45 The Vineyard Planning Changes

Date: August 2024
Doc No. 5008

Revision G

Since activating the planning permission (ref 19/0954/VRC) the scheme has undergone both a stage 3 design review and stage 4 design development. This document seeks to present the design updates with a view to substituting the existing planning drawings with an updated set to maintain the completeness of the consent, for the avoidance of doubt and in the interests of proper planning. The design updates have been made for the following reasons:

B3R Architects

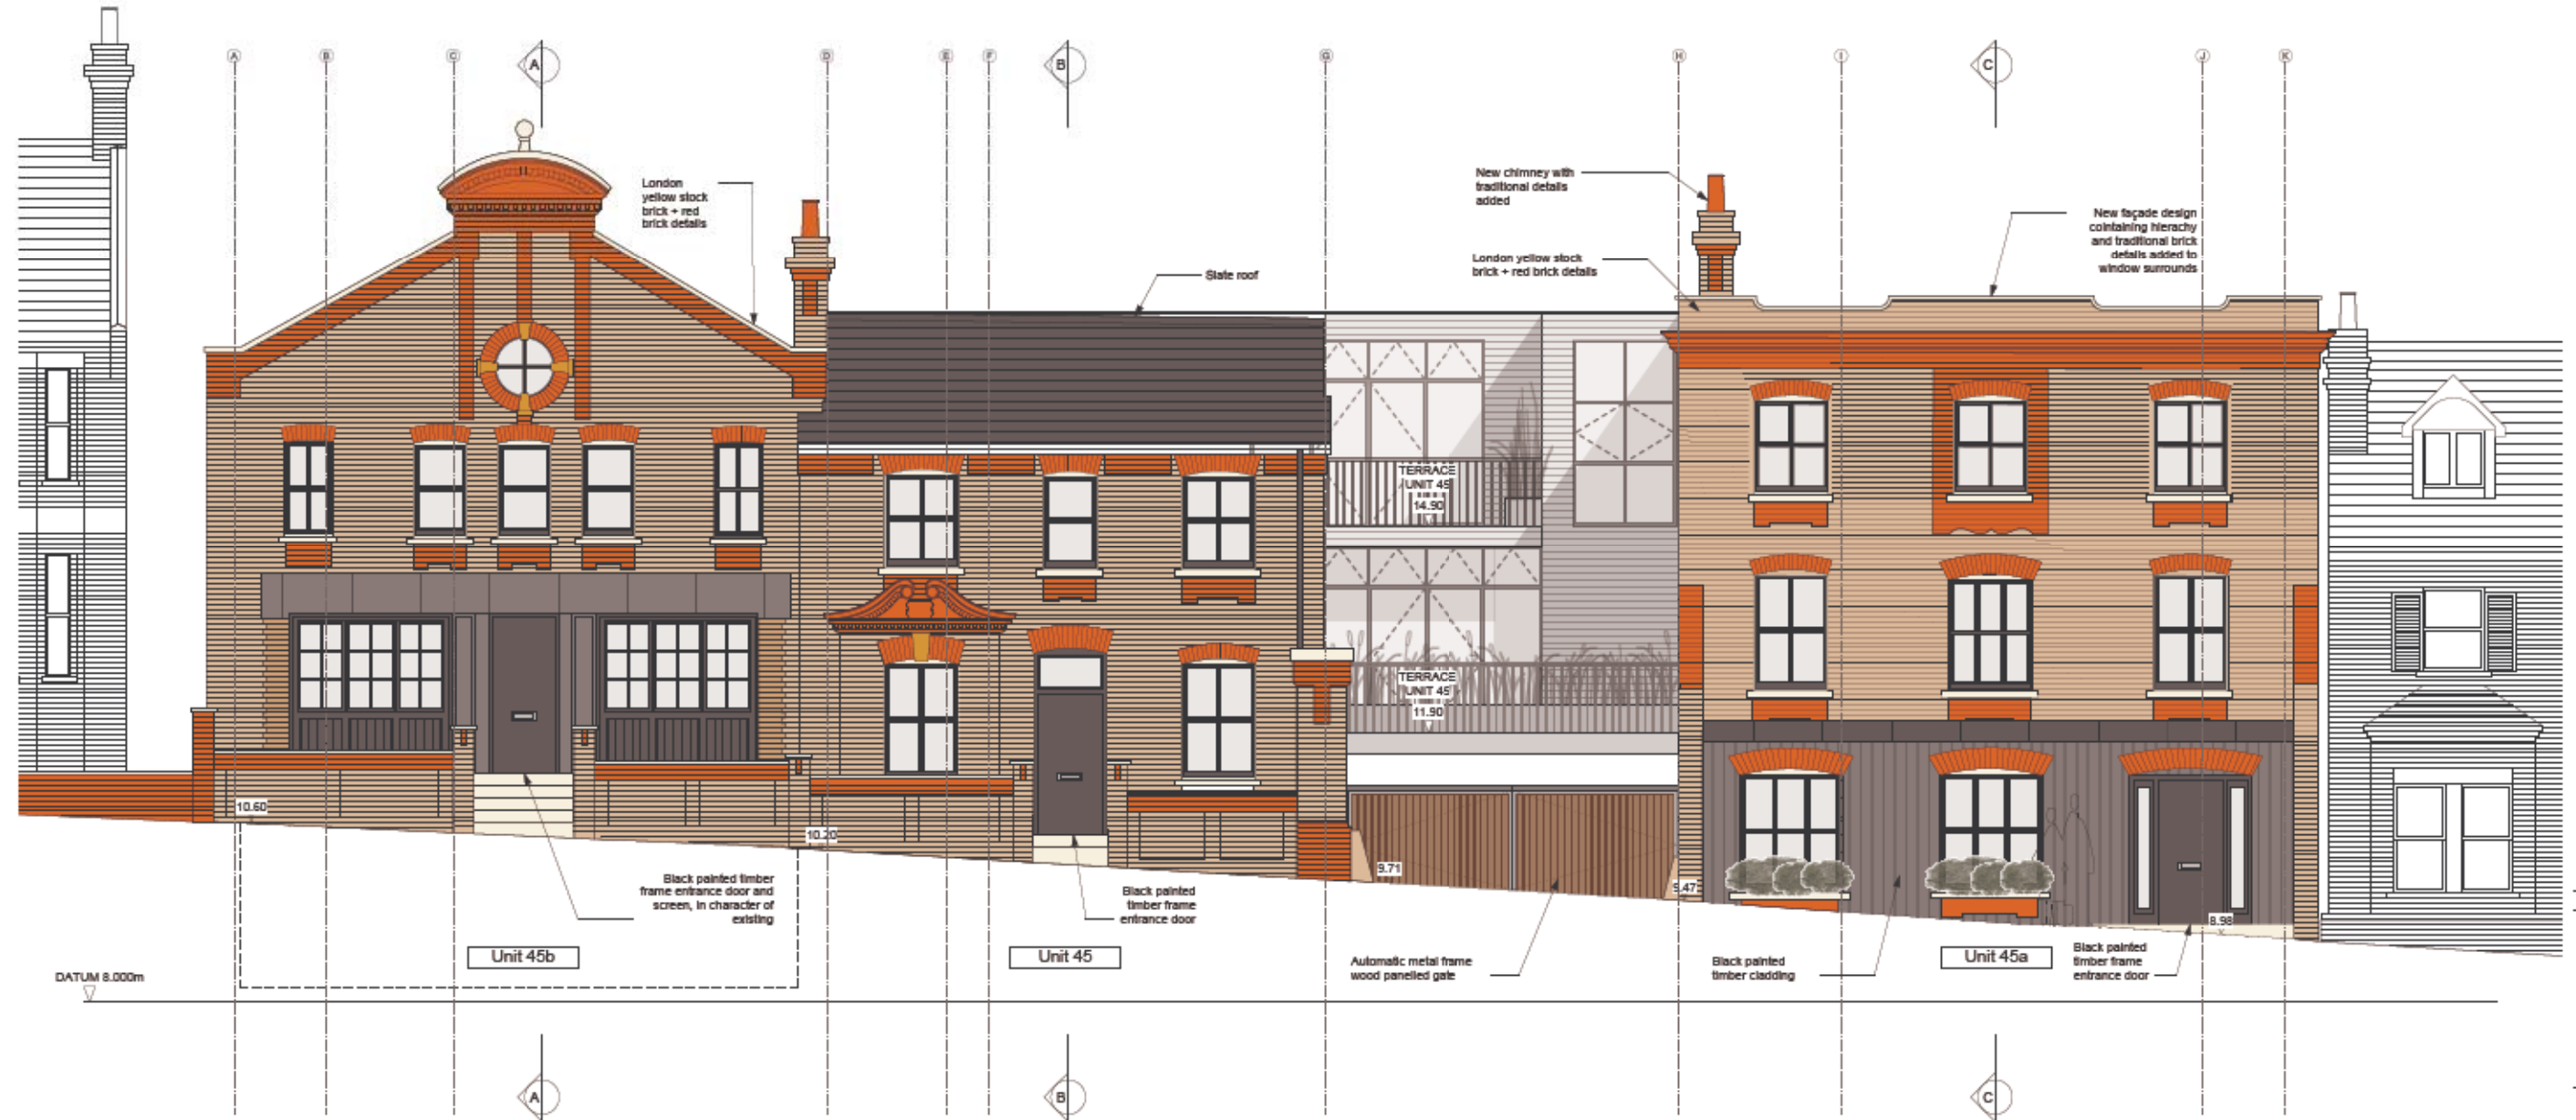
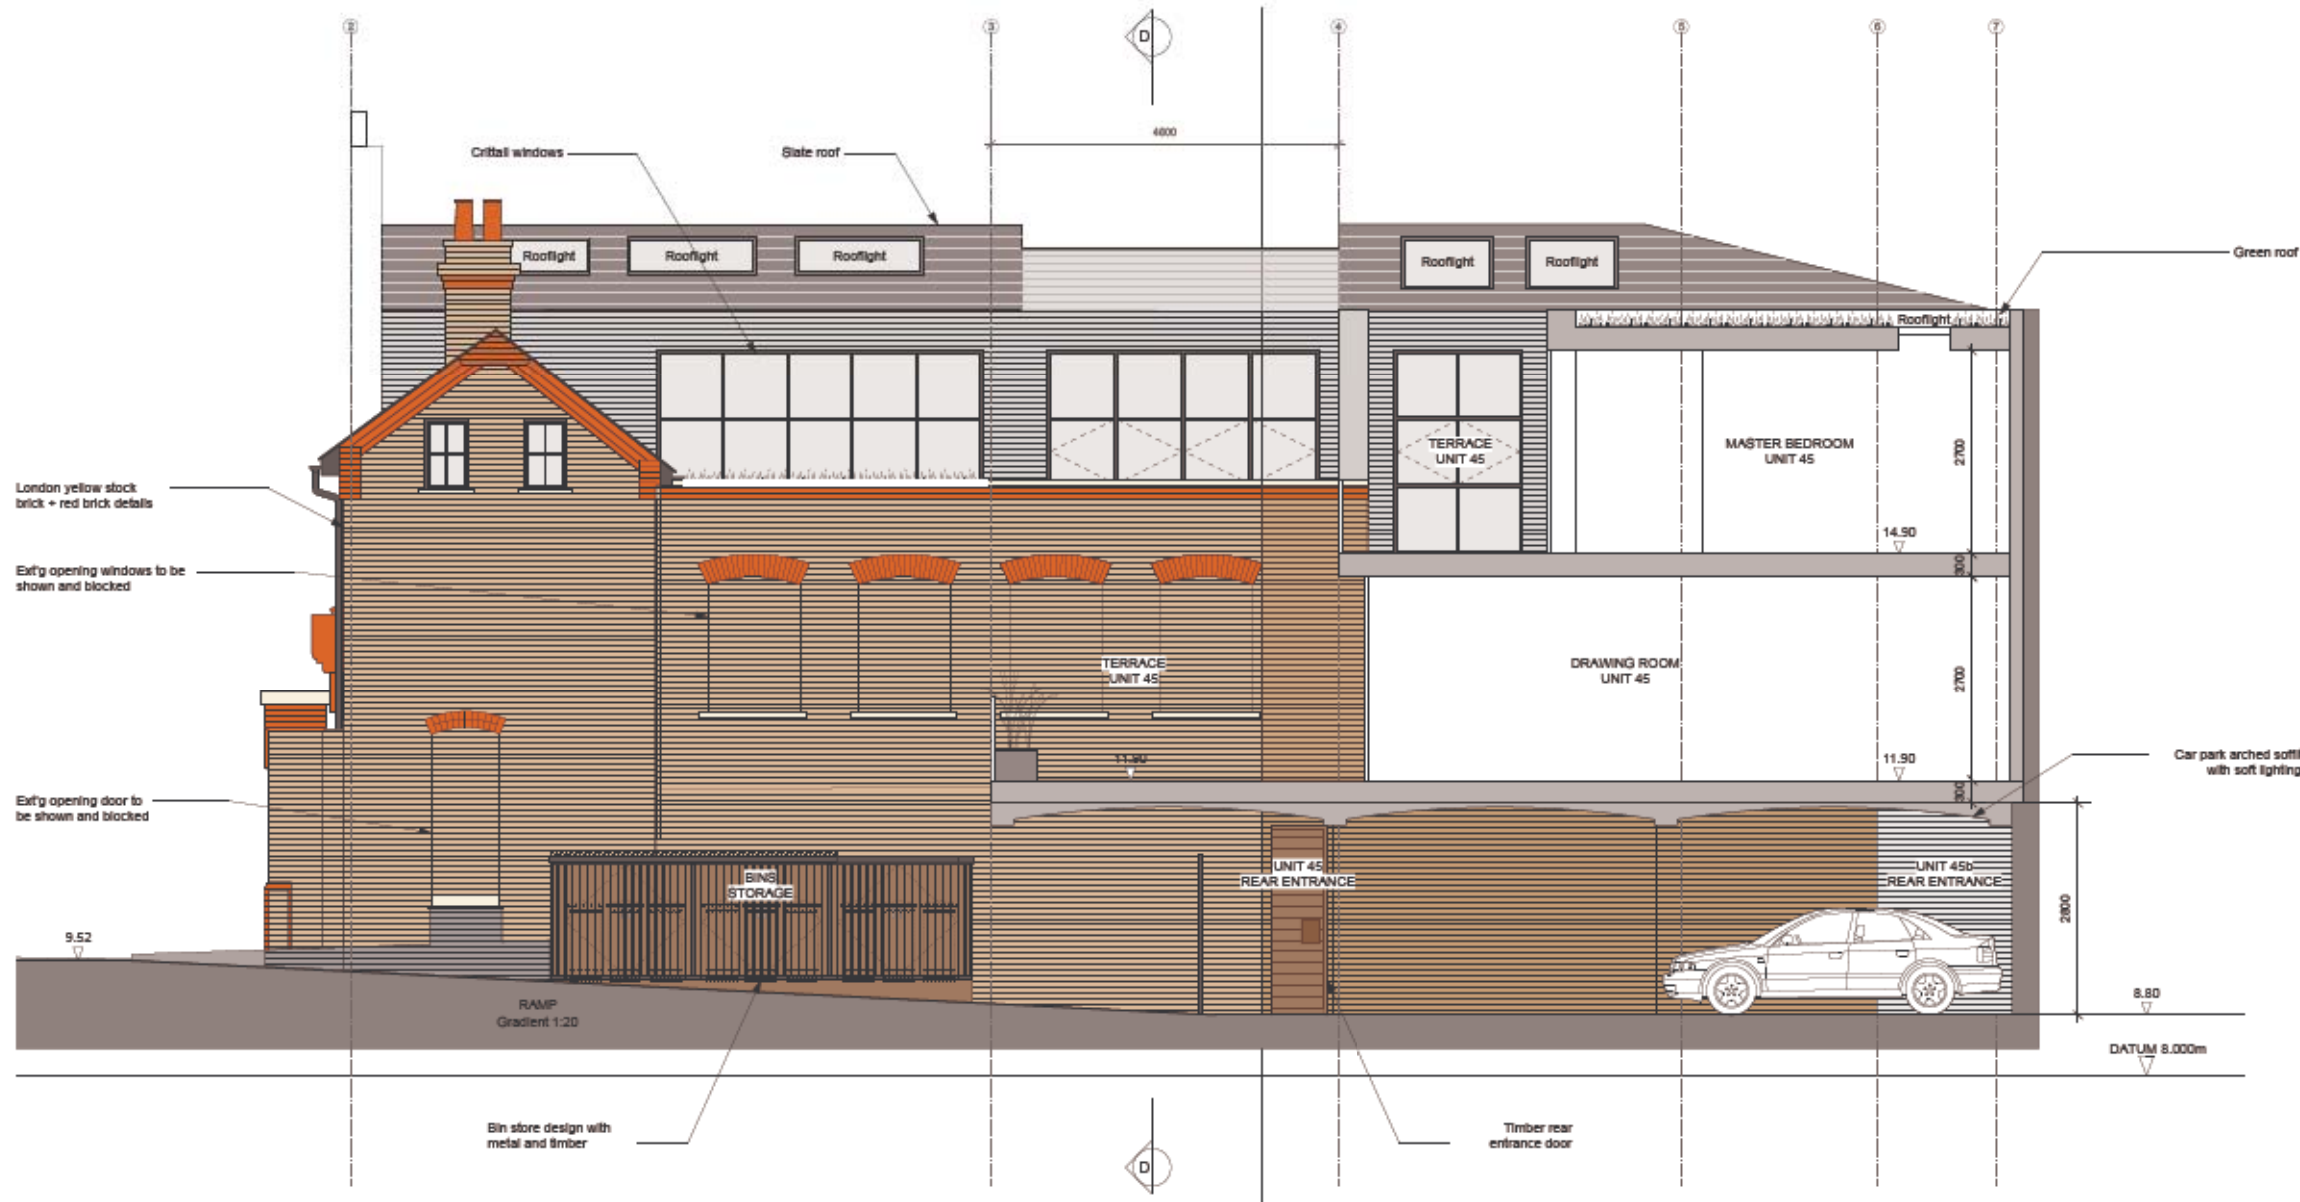
- A INTERNAL ARRANGEMENT AMENDED (SEE SUMMARY OF INTERNAL CHANGES IN SEPARATE DOC)
- B BICYCLE STORAGE ARRANGED AROUND COURTYARD (CLOSER TO UNIT ENTRANCES)
- C LEVEL ENTRANCE TO 45A
- D ENTRANCE LEVEL SHOWN HERE (BEDROOM SHOWN ON LEVEL 02) - NOTE: ACTUAL LEVEL TO THESE ROOMS REMAINS THE SAME
- E TERRACE DIVIDED BETWEEN UNITS WITH GREEN WALL
- F COURTYARD FLANK WALL LOWERED IN HEIGHT (SEE ELEVATION)
- G TERRACE ADDED
- H WINDOW AMENDED (POSITION OR SIZE)
- I ROOFLIGHT OMITTED
- J GREEN ROOF OMITTED
- K -
- L SOFFIT PROFILE CHANGED
- M BRICK SOLDIER COURSE OMITTED
- N SERVICE ENCLOSURES CHANGED
- O PRIVACY SCREEN ADDED
- P CAR PARK GATE AMENDED
- Q PLANT ROOM DOOR ADDED
- R WINDOW POSITION AMENDED
- S -
- T PV PANEL ADDED
- U WINDOW OMITTED

Drawing Title
WEST SIDE SECTIONAL ELEVATION PROPOSED

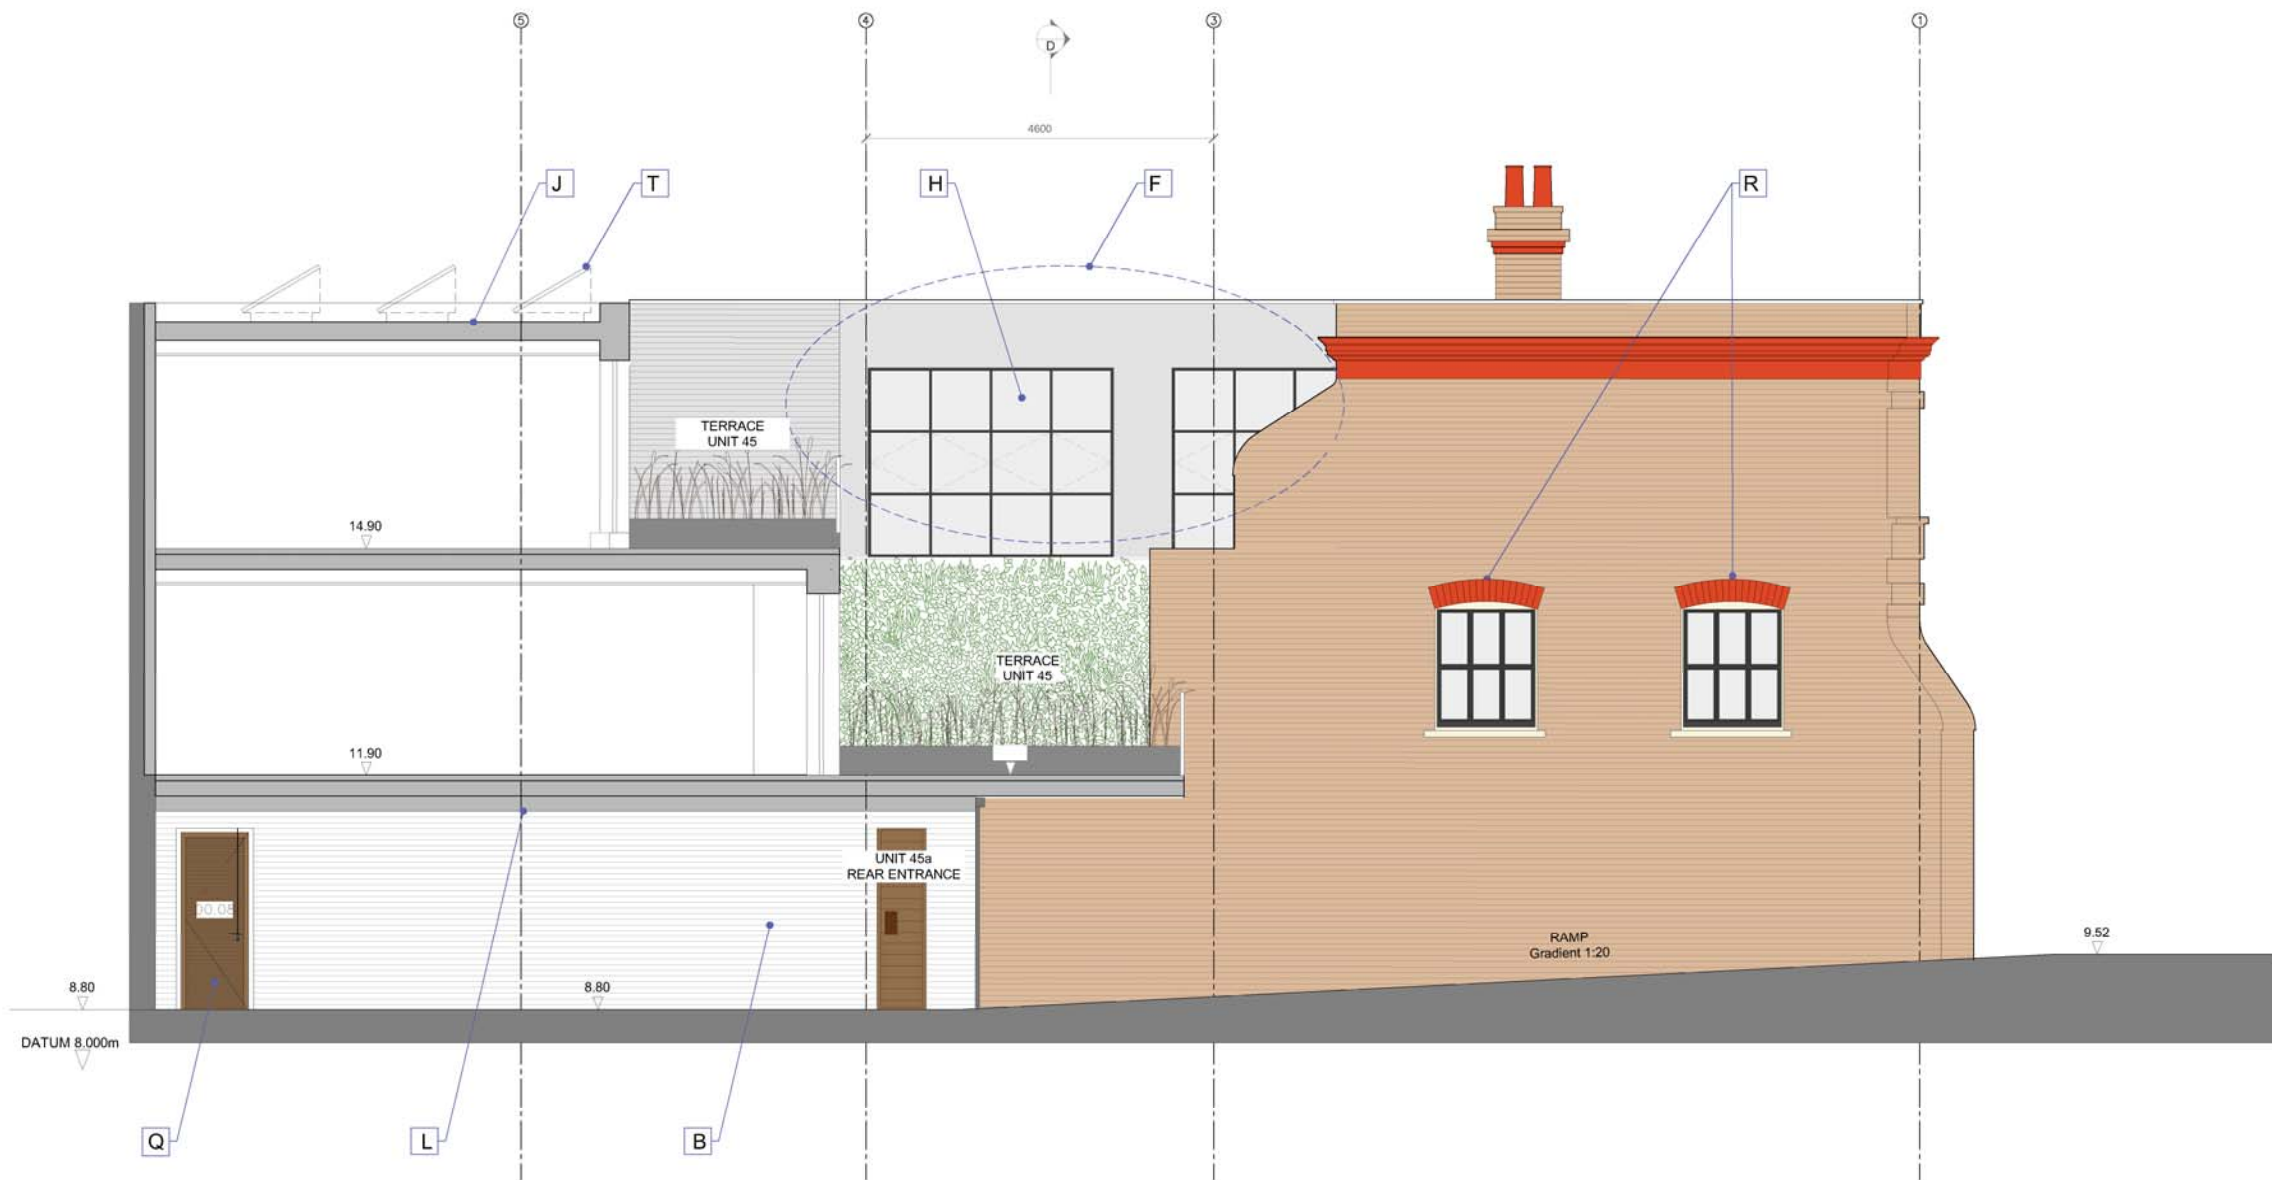
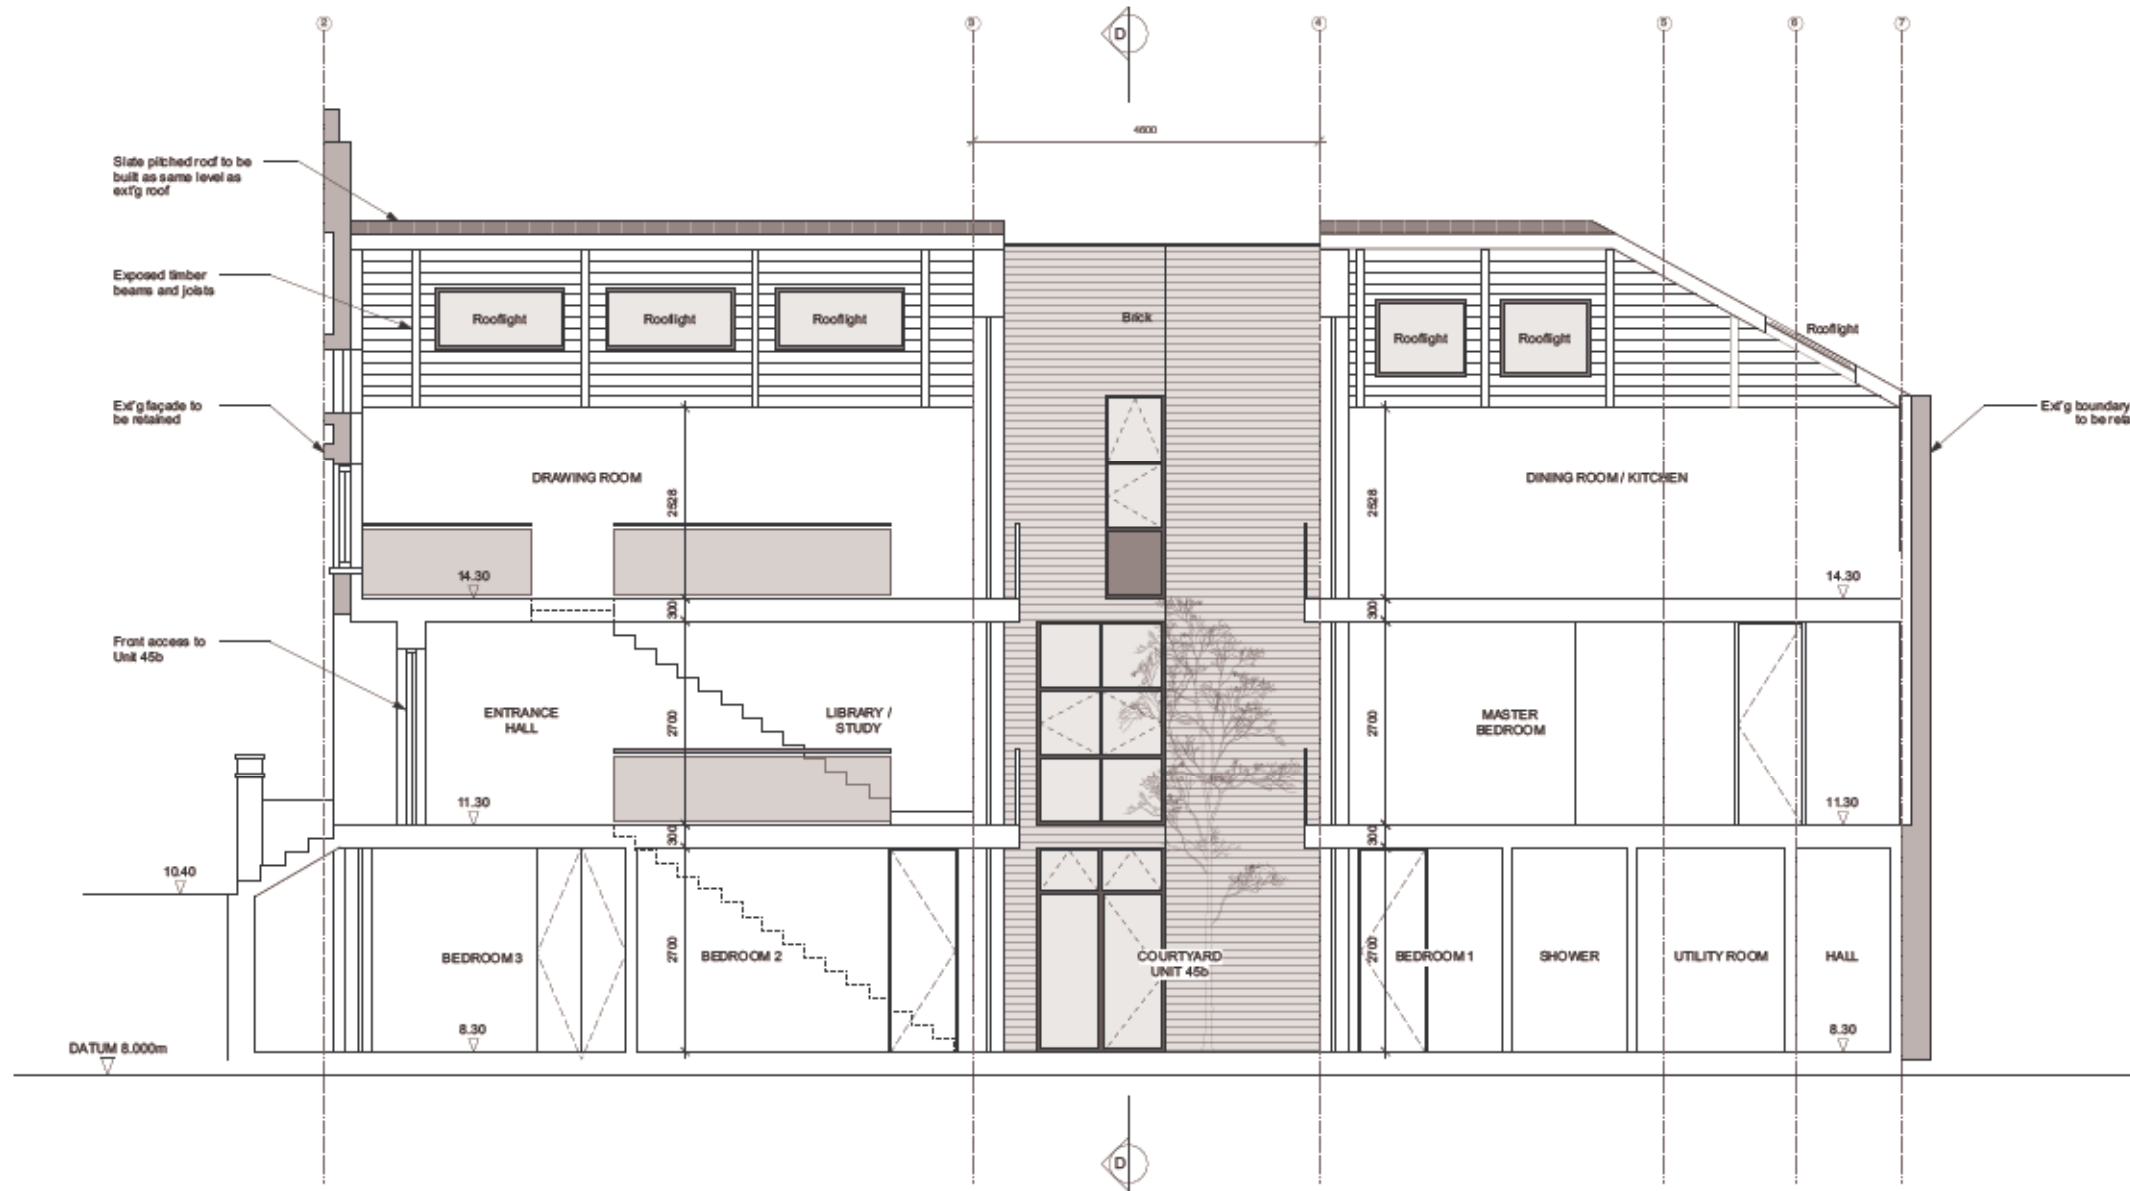
- A INTERNAL ARRANGEMENT AMENDED (SEE SUMMARY OF INTERNAL CHANGES IN SEPARATE DOC)
- B BICYCLE STORAGE ARRANGED AROUND COURTYARD (CLOSER TO UNIT ENTRANCES)
- C LEVEL ENTRANCE TO 45A
- D ENTRANCE LEVEL SHOWN HERE (BEDROOM SHOWN ON LEVEL 02) - NOTE: ACTUAL LEVEL TO THESE ROOMS REMAINS THE SAME
- E TERRACE DIVIDED BETWEEN UNITS WITH GREEN WALL
- F COURTYARD FLANK WALL LOWERED IN HEIGHT (SEE ELEVATION)
- G TERRACE ADDED
- H WINDOW AMENDED (POSITION OR SIZE)
- I ROOFLIGHT OMITTED
- J GREEN ROOF OMITTED
- K -
- L SOFFIT PROFILE CHANGED
- M BRICK SOLDIER COURSE OMITTED
- N SERVICE ENCLOSURES CHANGED
- O PRIVACY SCREEN ADDED
- P CAR PARK GATE AMENDED
- Q PLANT ROOM DOOR ADDED
- R WINDOW POSITION AMENDED
- S -
- T PV PANEL ADDED
